PCI COMMITTEE REPORT

PCI Standard Design Practice

PCI Standard Design Practice[†]

Comments by Alex Aswad, George Laszlo, Alan H. Mattock, Antoine E. Naaman, H. Kent Preston and Committees Closure

Fig. A. Primary moment diagram.

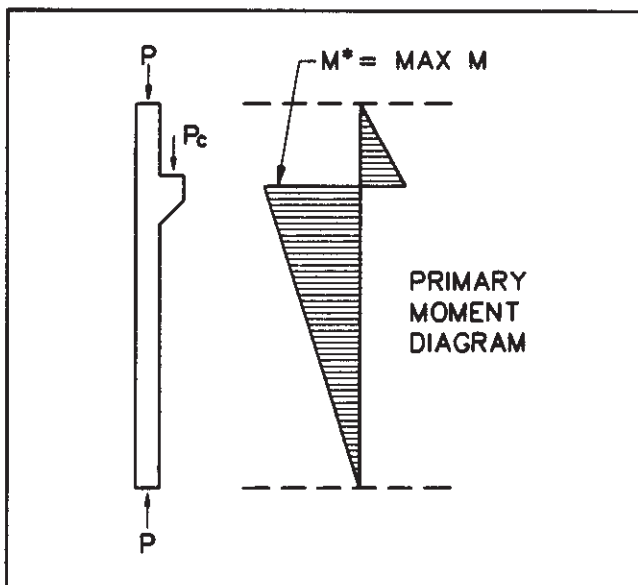
I strongly recommend changing $0.75f_{ci}'$ to read instead: “... $0.67f_{ci}'$ near midspan and $0.70f_{ci}'$ at the beam’s ends.”
